FIELD ADVISORY

FA#95-007 Revised
August 15, 1995

SUBJECT: 86XX DESENSE AND MICROPHONICS

This is a revision to FA95-007, dated June 28, 1995. Please note that step seven of the microphonic procedure on the following page has been changed to only apply to 8605/06/10/15/16/21/22 model radios. It does not apply to 8600/01/02/04/22/25/30/40/44/55 radios. Please discard FA95-007 and replace it with this document.

FIGURE 1

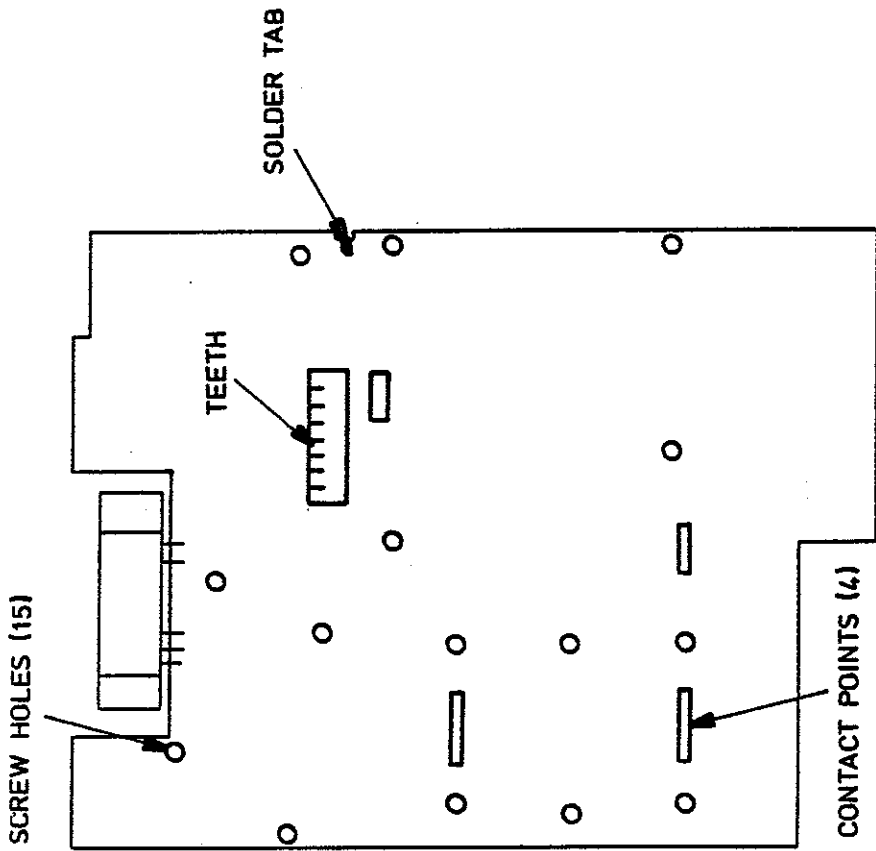
4. Thoroughly clean all points on the main board that make contact with the bottom shield (teeth and screw hole contact points). Remove any excess solder and solder resist that may interfere with the contact between the shield and the main board. See Figure 1.

7. Solder the Z200 ground bracket tab nearest to the wall of the radio to its ground trace located near the edge of the bottom side of the main board if required. Remove the solder resist if necessary. See Figure 1.

8. Apply a thin layer of contact lube to the teeth and screw hole contact points on either the main board or the bottom shield itself. See Figure 1.

FIGURE 2

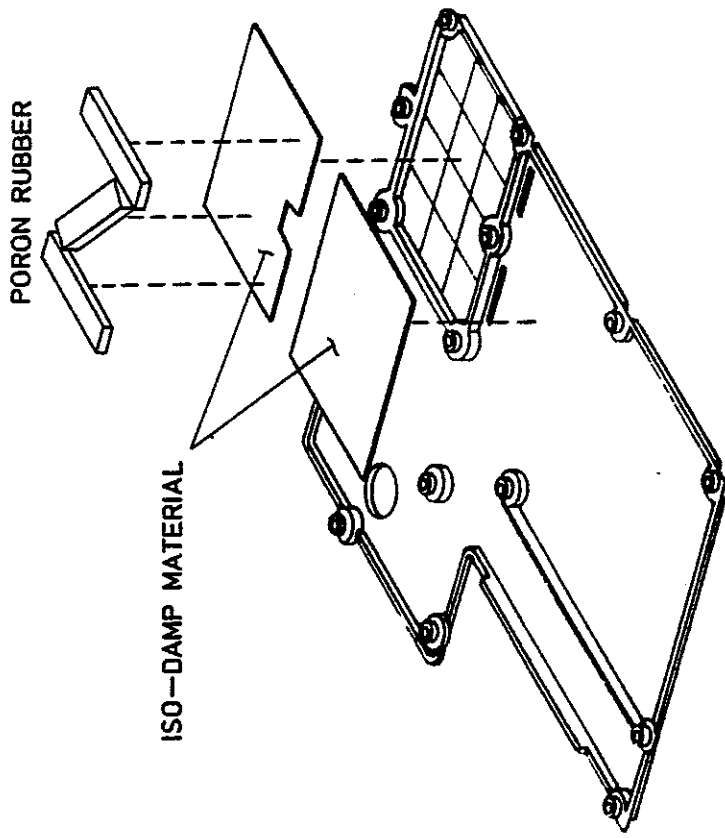
1. Follow steps 1 through 8 in the Desense section of this field advisory.
2. Install iso-damp material on the inside side of the bottom shield as shown in Figure 2. On the newer 1-piece bottom shield (p.n. 015-0920-118) trim the one iso-damp piece shown to fit in the cavity and around the notch.

4. Install three one inch strips of poron rubber as shown in Figure 2.
5. Re-install the main board bottom shield. Be sure the shield screws are tight (don't over-tighten).
